Technical Service Bulletin

SUBJECT:
Incorrect Engine Oil
Dipstick

NO: 09-06-98
GROUP: Engine
DATE: Oct. 30, 1998

1998 (BR/BE) Ram Truck

FIGURE 1

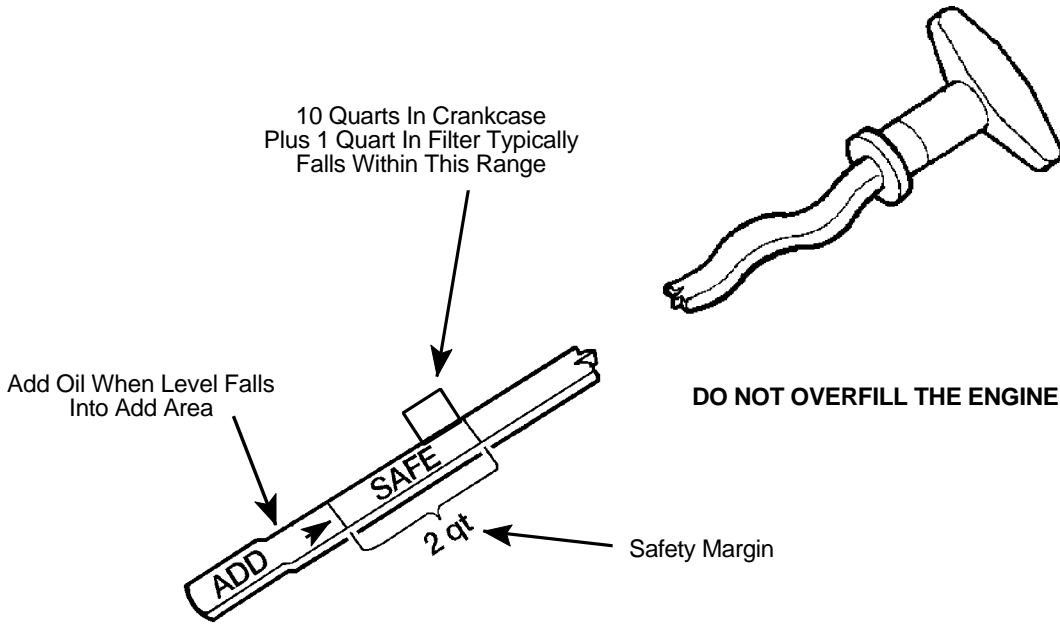
NOTE: THE TOTAL CAPACITY OF THE CRANKCASE IS 10 QUARTS PLUS 1 QUART IN THE FILTER. THE OIL LEVEL TYPICALLY READS IN THE MID TO UPPER SECTION OF THE SAFE ZONE WHEN FULL. IT DOES NOT HAVE TO BE FILLED TO THE TOP EDGE OF THE SAFE ZONE FOR THE LEVEL TO BE CORRECT (FIGURE 1).
